Amendments to the Drawings

Remarks

Application No. : 10/632,576 Confirmation No.: 5022
Applicant(s) : John LeRoy Parker and Pamela L. Miscikowski
Filed : 07/28/2003
TC/Au : 3729
Examiner : Cathy Lam
Title : VIA CONNECTOR AND METHOD OF MAKING SAME
Docket No. : 8245.057
Customer No. : 30589
Express Mail No : EV 616014556 US Deposited On: 09/21/2007

FIG. 3

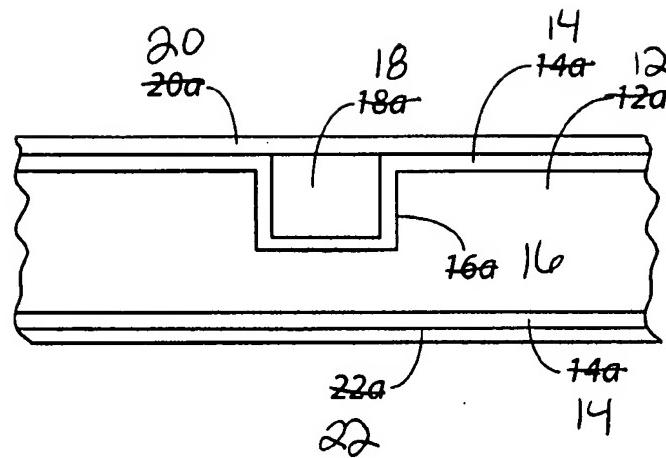
Objections to the Drawings

In the Office Action dated April 4, 2007, the drawings were objected to for inconsistency. Applicants herein amend Figure 3 to correct for inconsistencies. Specifically, Numerals 12a, 14a, 16a, 18a....etc have been amended to Numerals 12, 14, 16, 18...etc. In view thereof, Applicants request Figure 3 be added to the current drawings.

The attached sheet of drawings includes changes to Figure 3. This sheet replaces the prior submitted Figure 3 drawing. In Figure 3, Numerals 12a, 14a, 16a, 18a, 20a, and 22a have been amended to Numerals 12, 14, 16, 18, 20, and 22.
